# CITY OF ALBUQUERQUE

June 25, 2018

**RE: Yale Retail & Apartments  
416 Yale Blvd SE  
Grading and Drainage Plan  
Engineer's Stamp Date: 06/18/18  
Hydrology File: K16D011**

Based upon the information provided in your submittal received 06/18/18, the Grading and Drainage Plan **is not** approved for Building Permit and SO-19 Permit. The following comments need to be addressed for approval of the above referenced project:

SHEET TITLE  
**GRADING PLAN**  
 SHEET NO:  
**C-1**

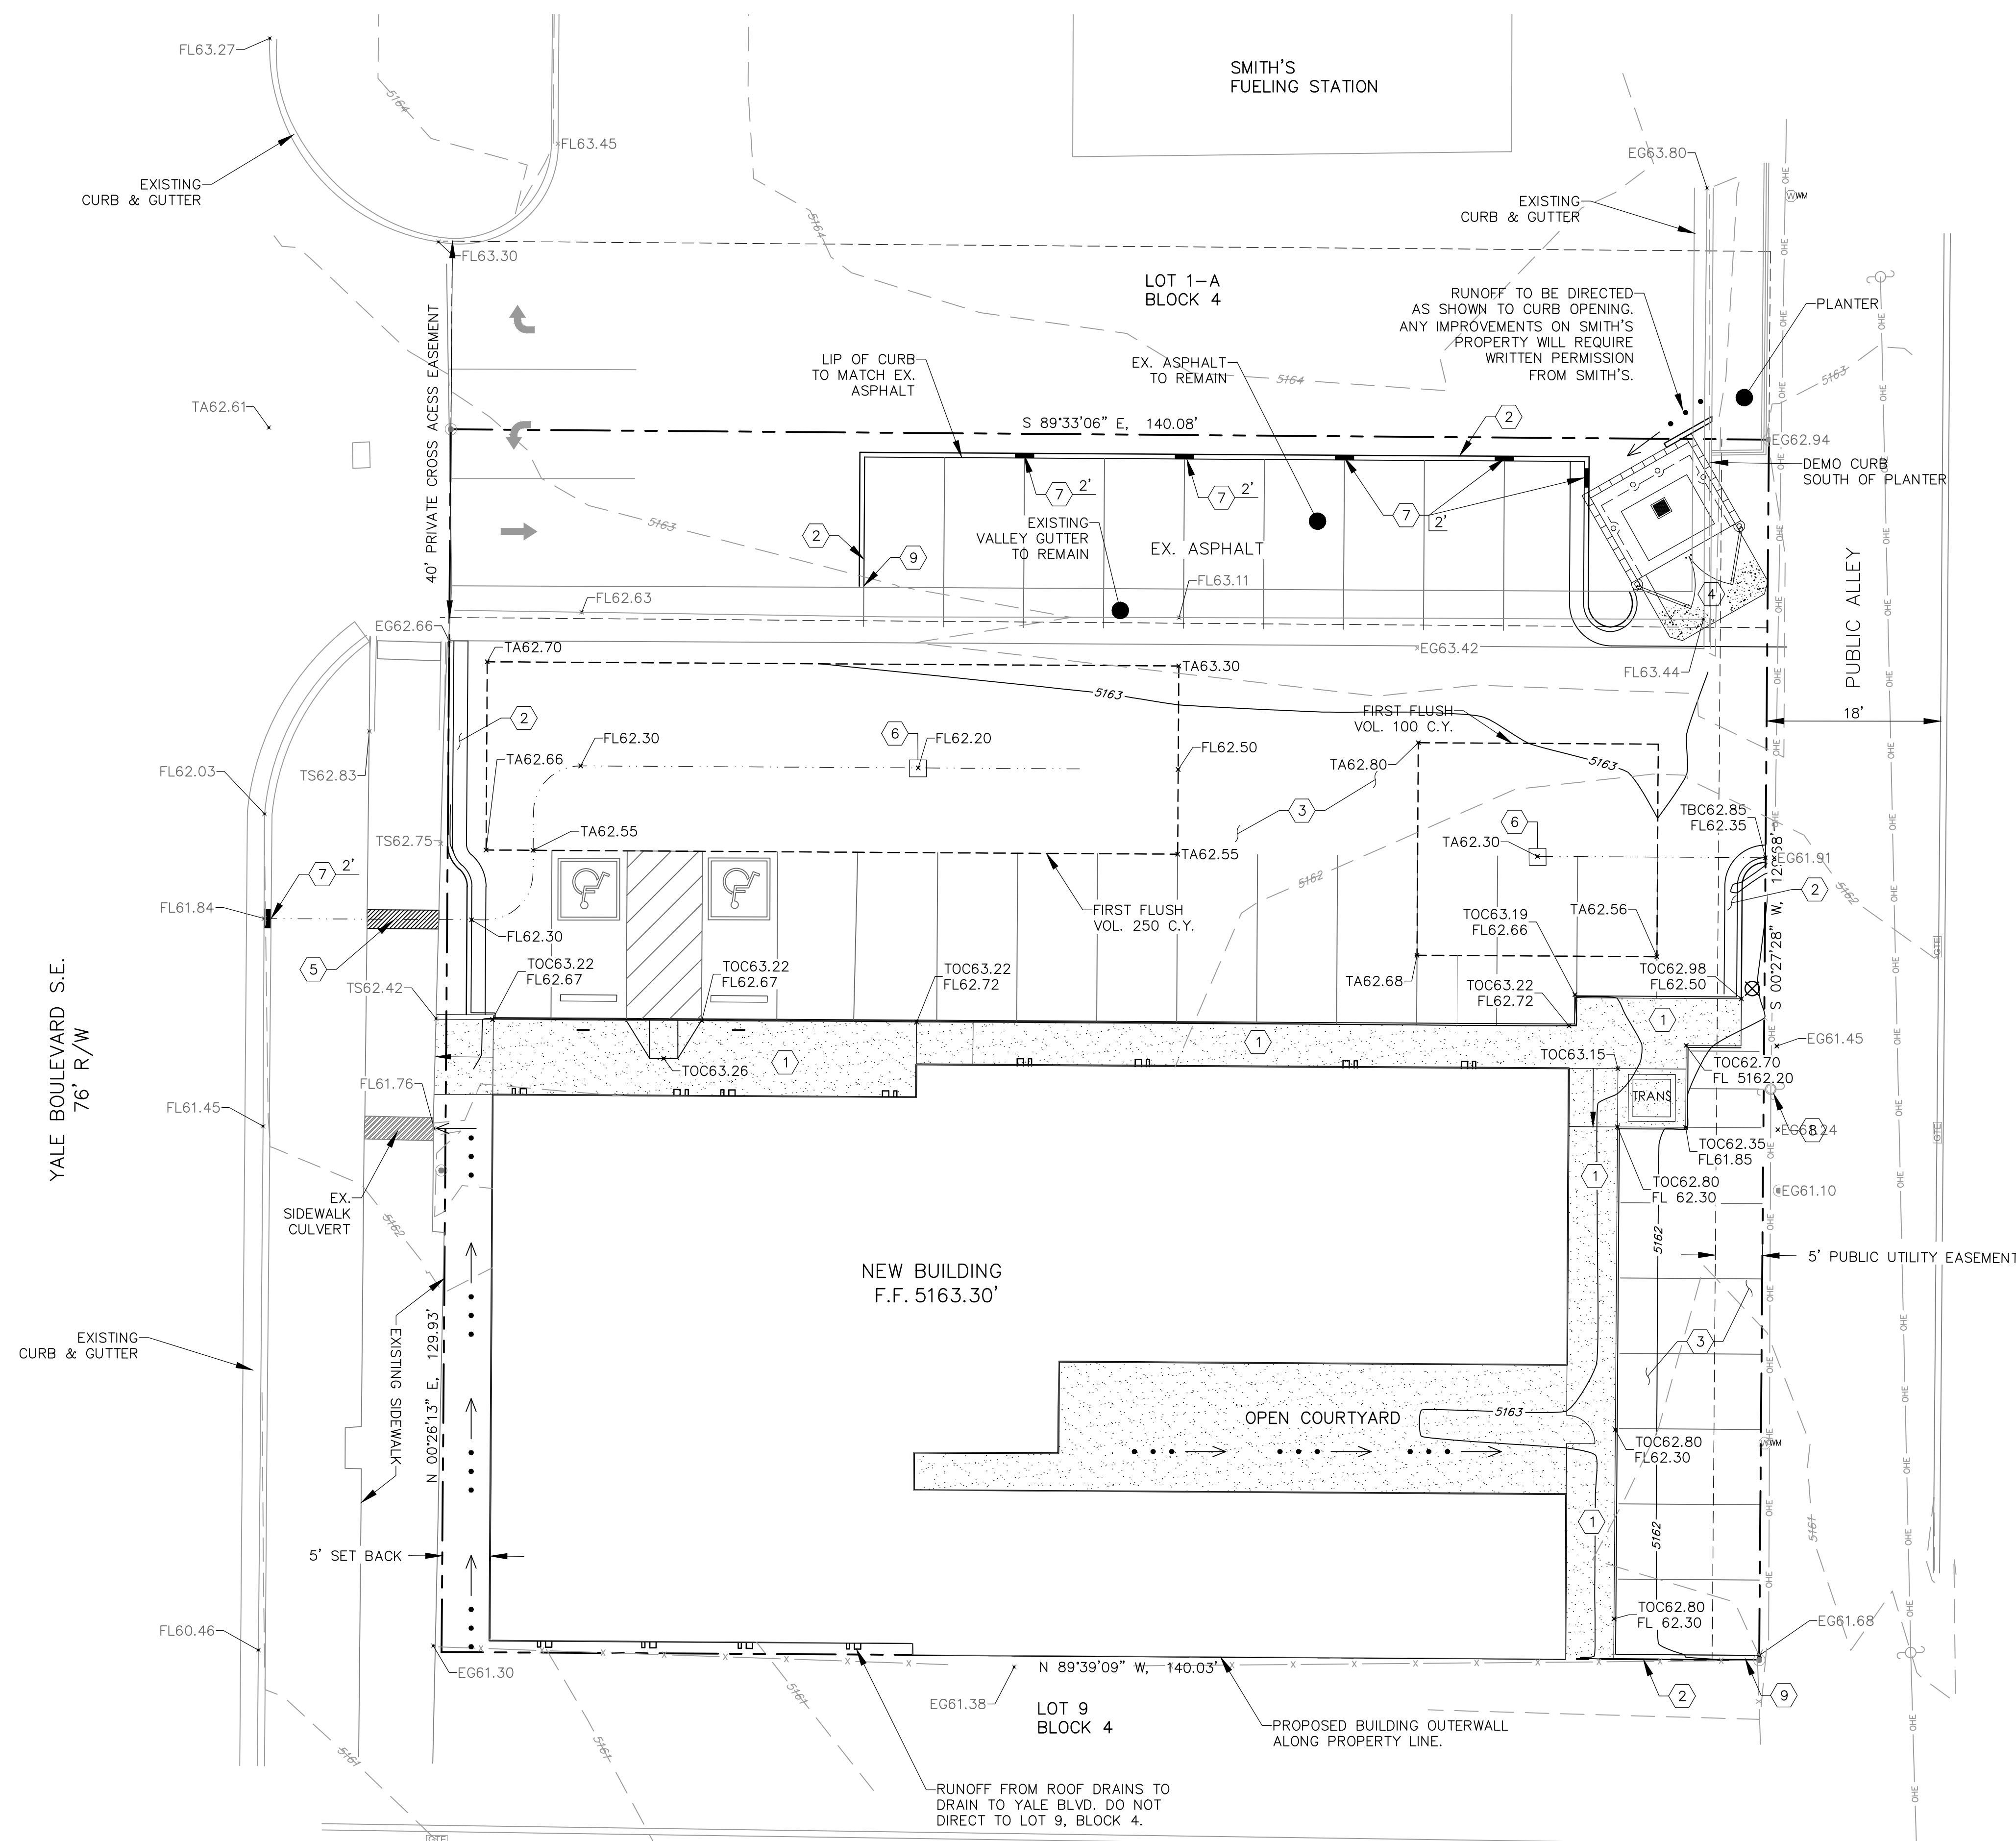
1. Sheet C-1. Please add a note to the existing sidewalk culvert, "Existing sidewalk culvert to be free of debris prior to Permanent Release of Occupancy by Hydrology.

2. Sheet C-1. At the southwest corner of the site there are too many contours with elevation 5161. It appears this area will drain from East to West towards Yale with elevations from 61.68 on the East side to 61.30 on the West. Please fix.

3. Sheet C-1. Please add the attached SO-19 notes.
4. Sheet C-1. The first flush volume cannot be provided within the drive aisle. The first flush must be in either a depressed landscaping area or an underground facility. If the site cannot support either, a Fee in Lieu must be paid for the required first flush volume of **424** cubic feet. The Fee in Lieu payment (Amount = 424 CF x \$8/CF = **\$3,392.00**) for the required first flush volume. If Fee in Lieu will be used, Then a note about this needs to be added to Sheet C-2.

SHEET NO: **C-2**

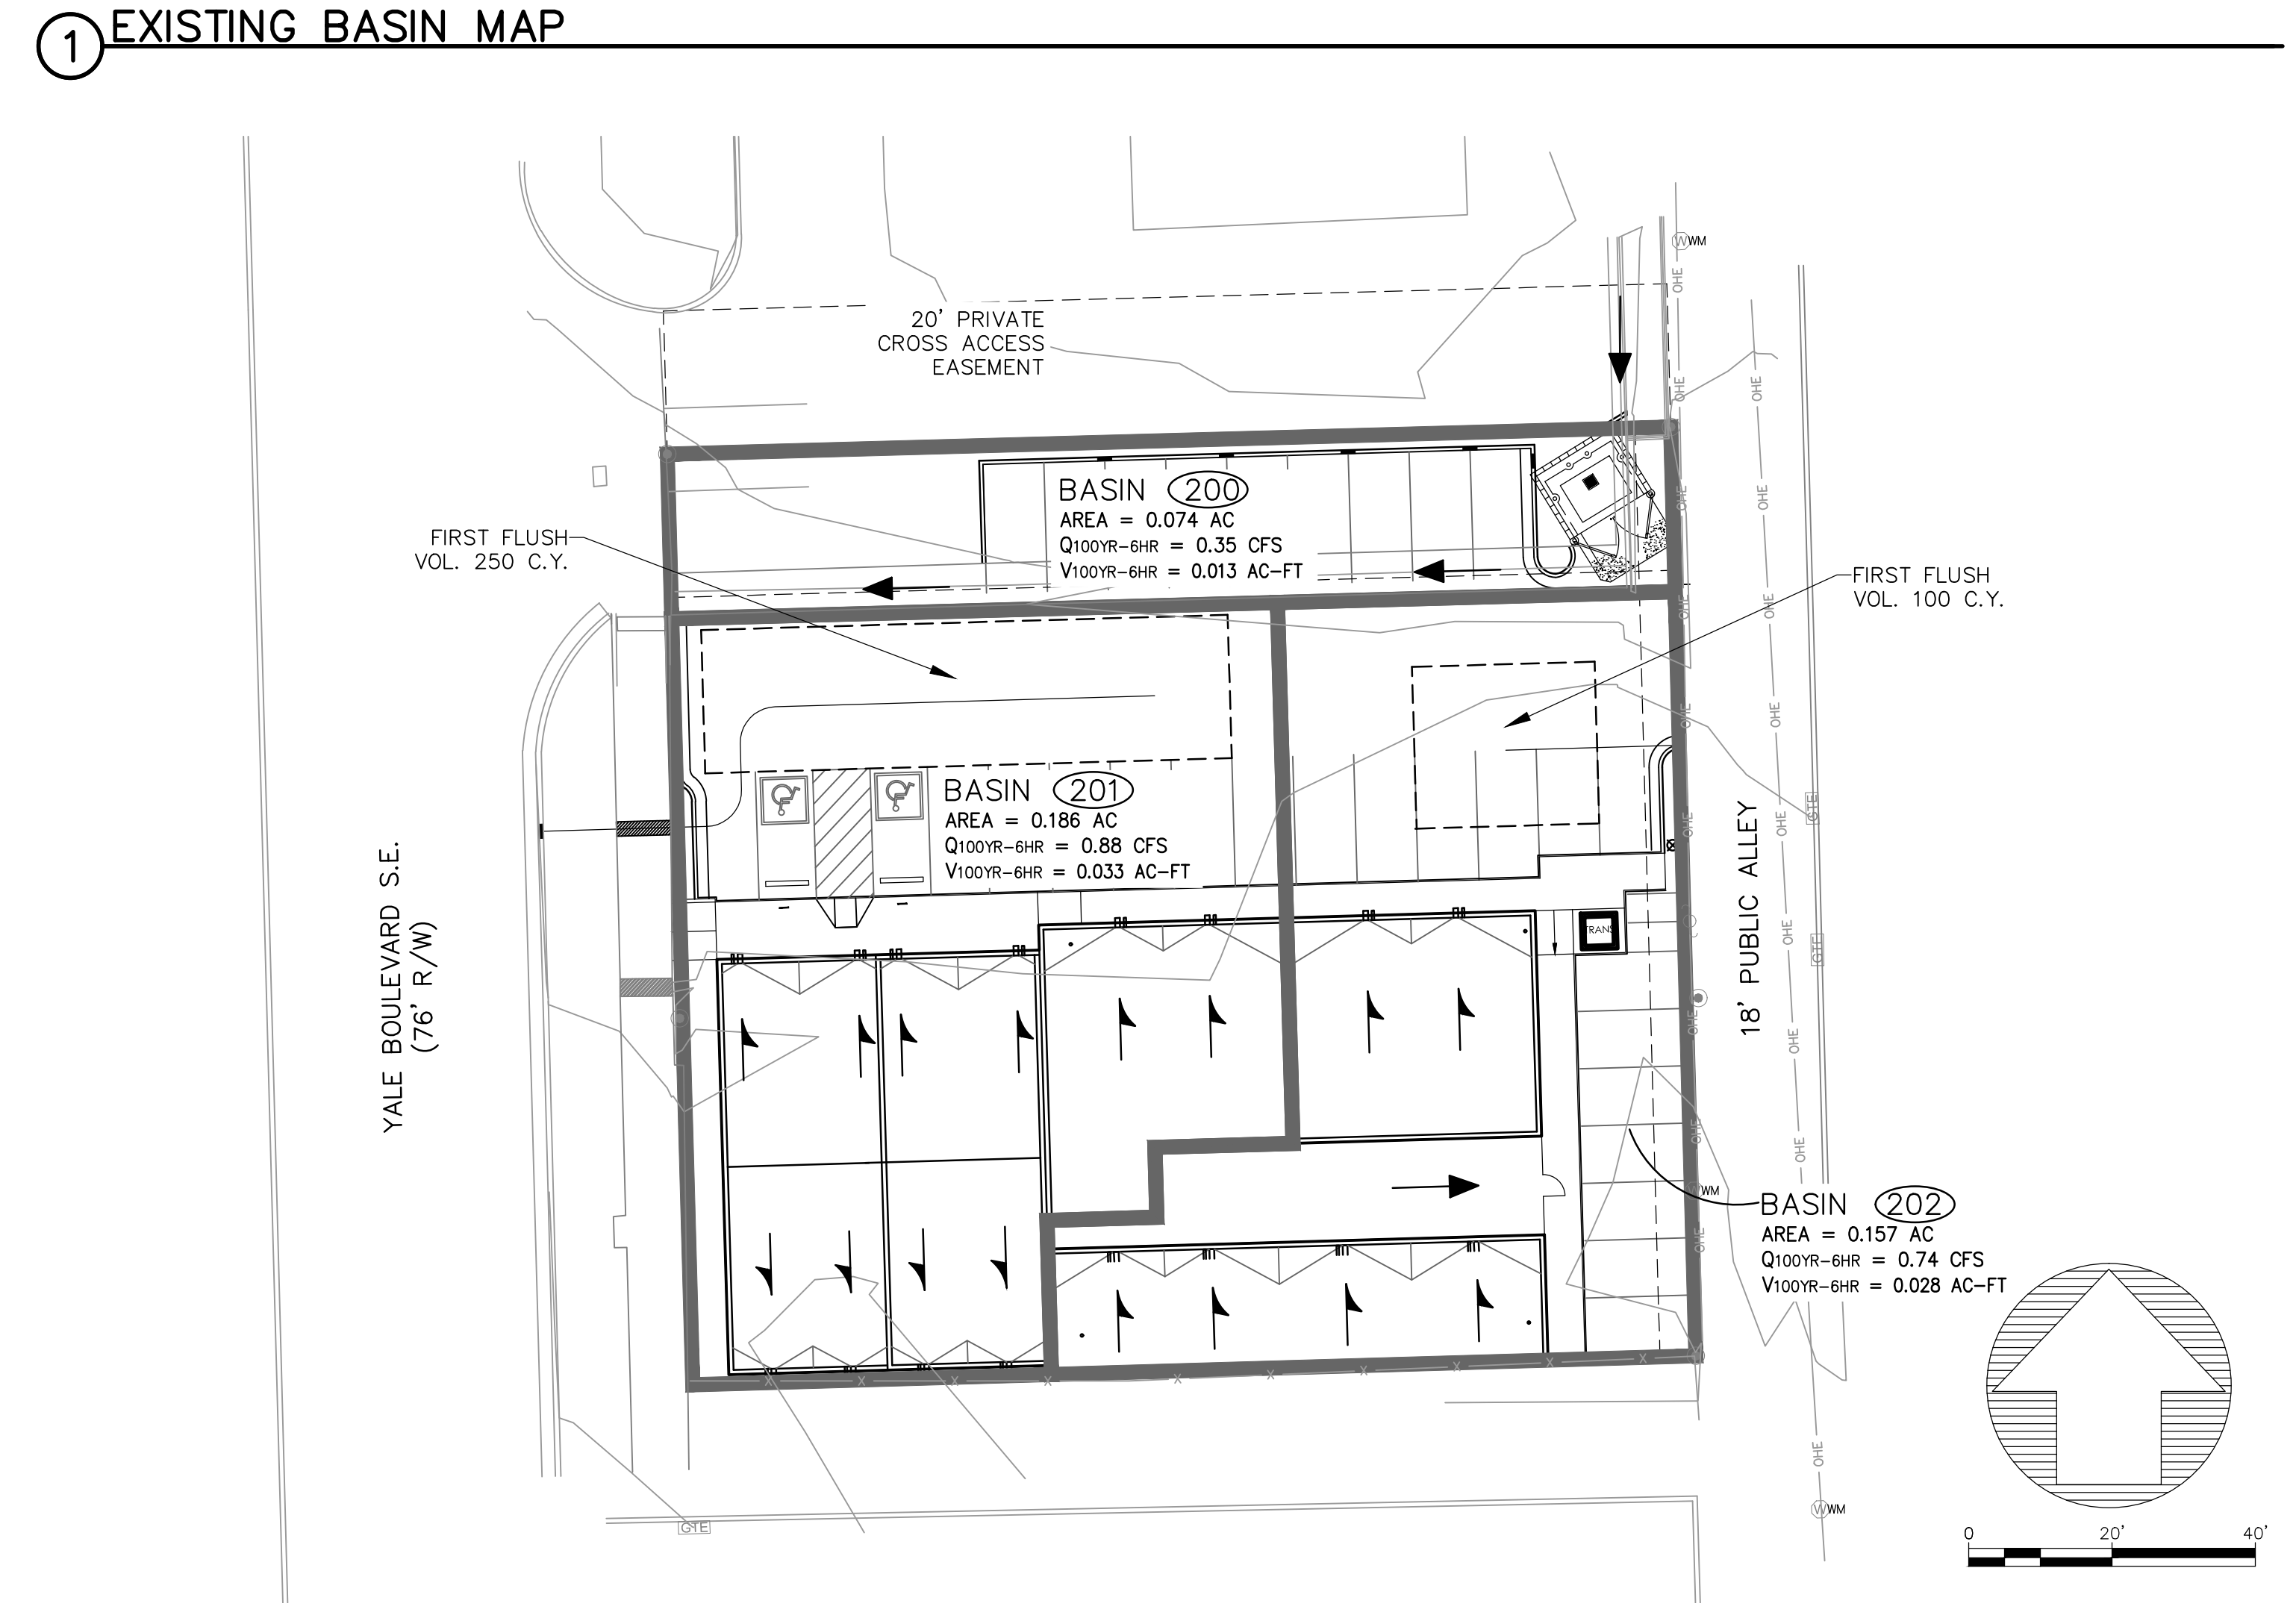
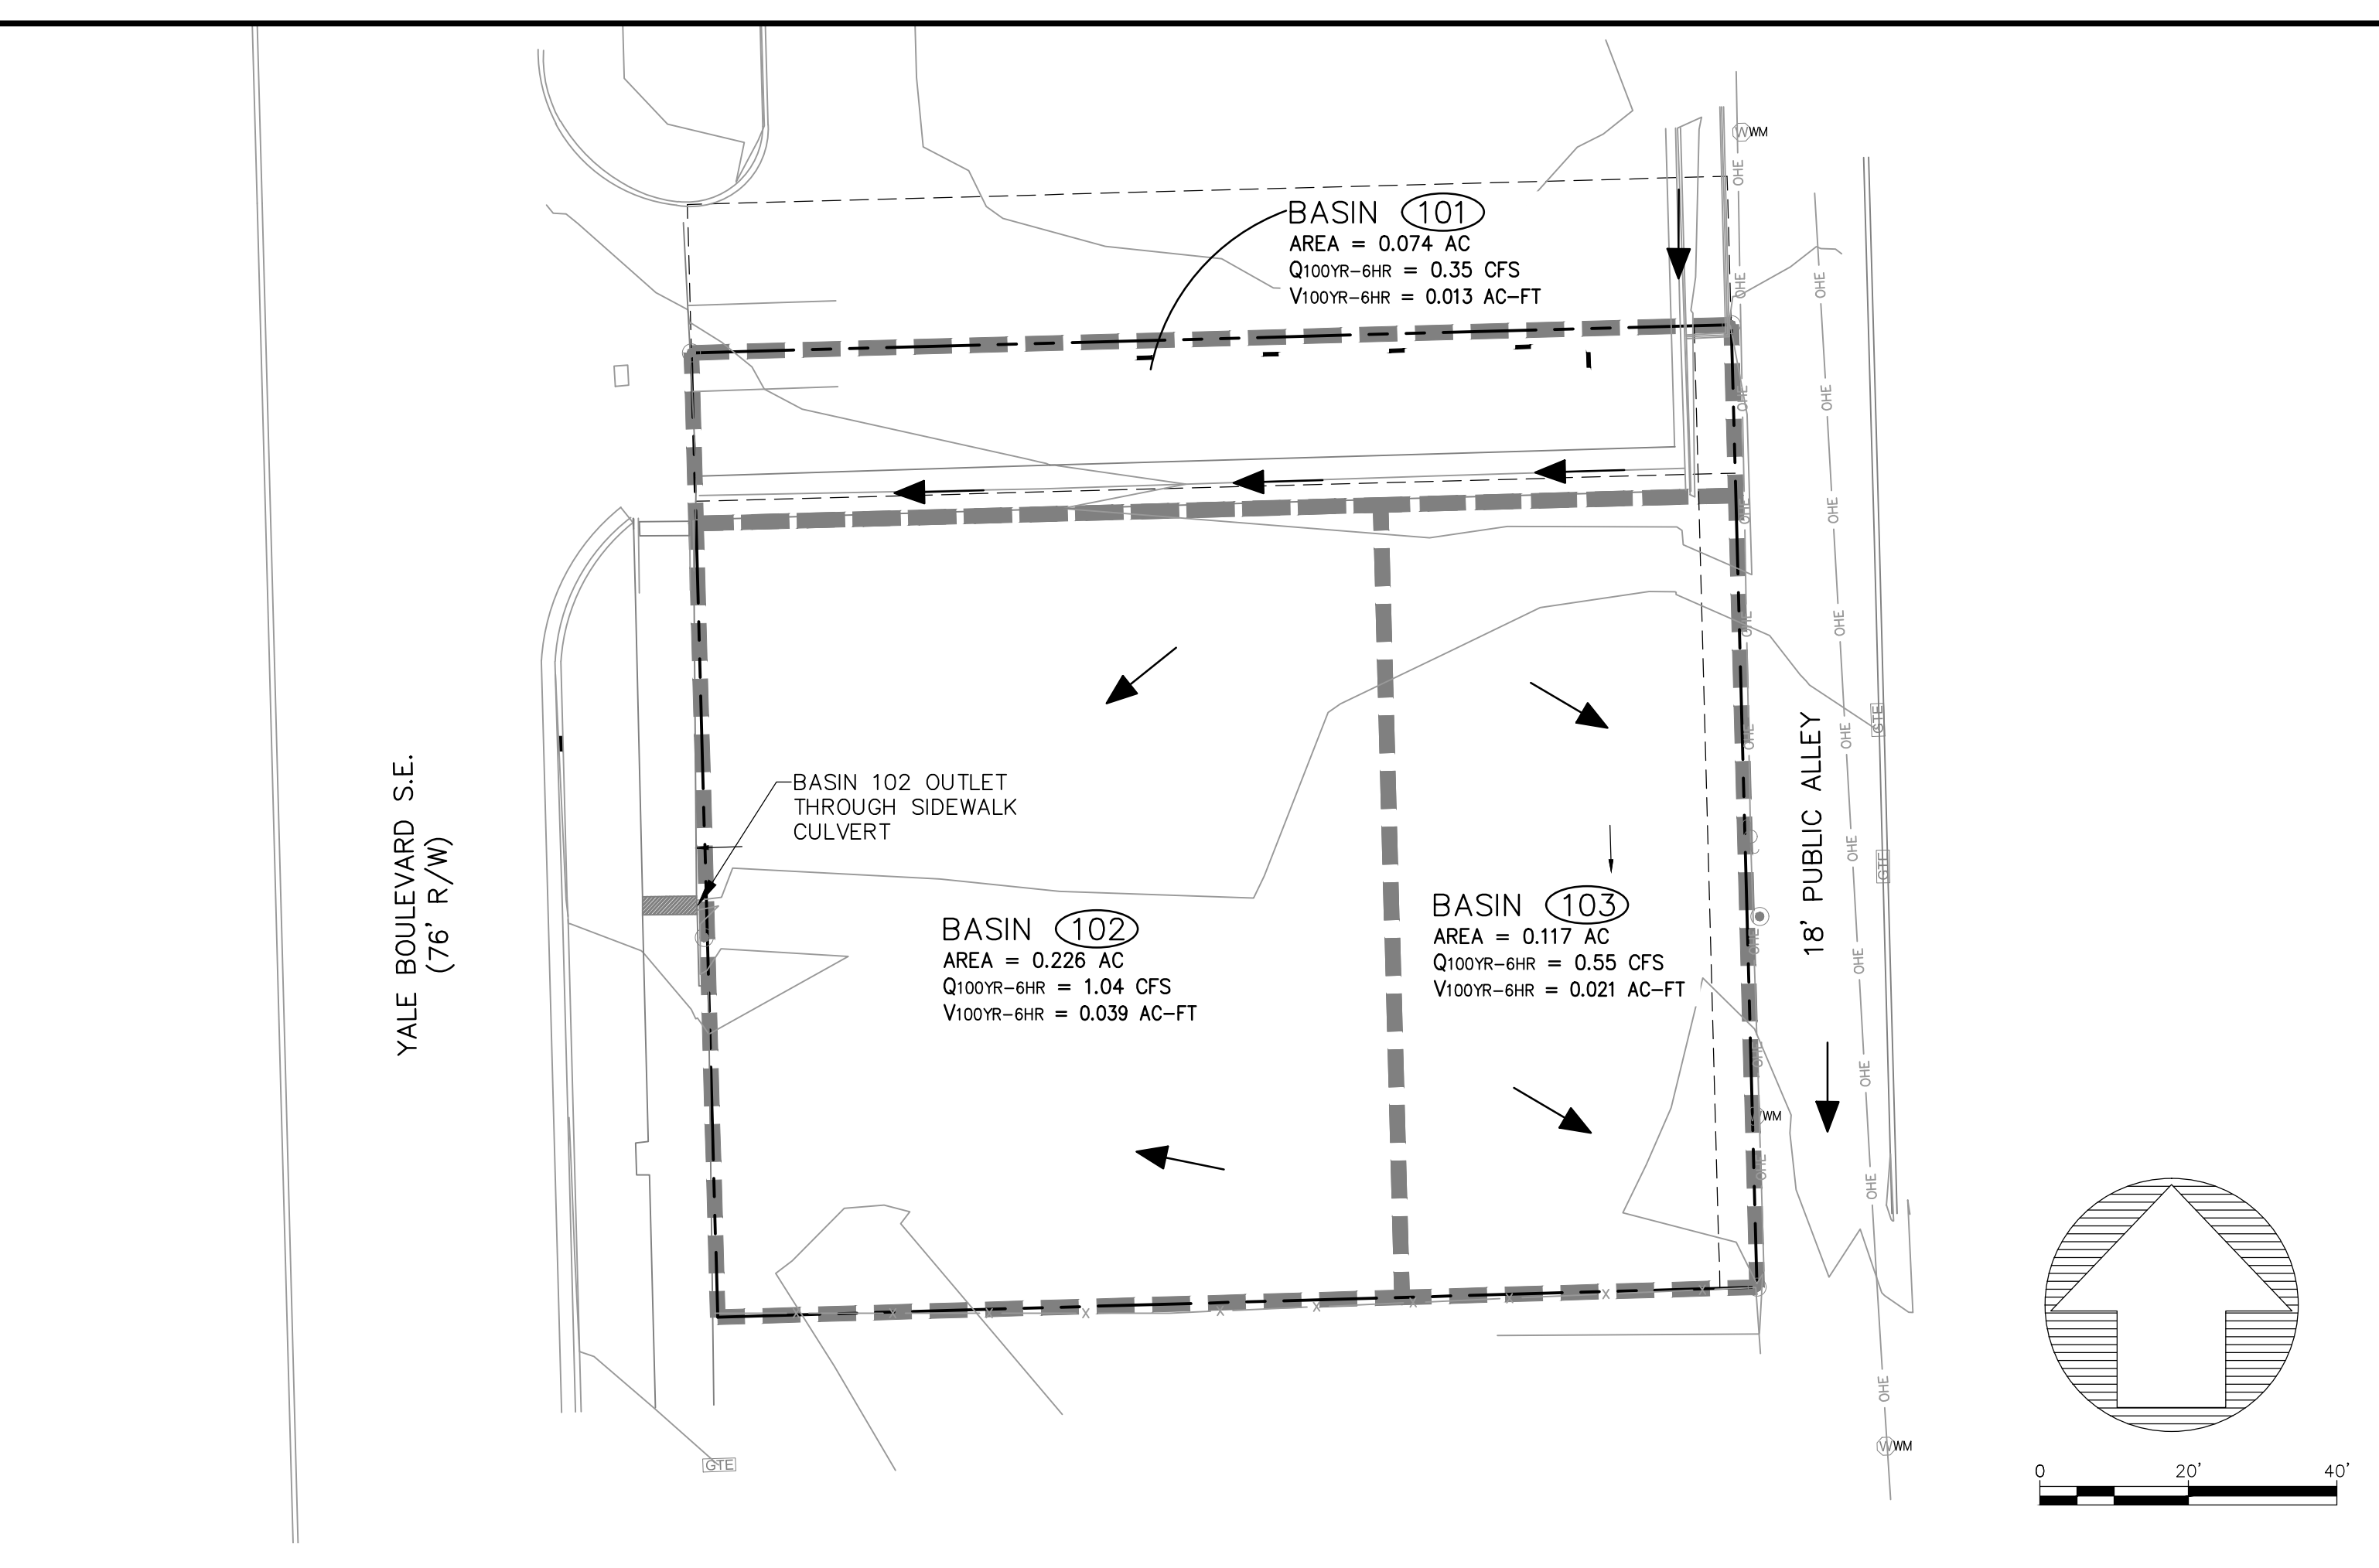
5. Sheet C-2. Please add the weir calculations for both the proposed sidewalk culvert and the proposed curb cuts.
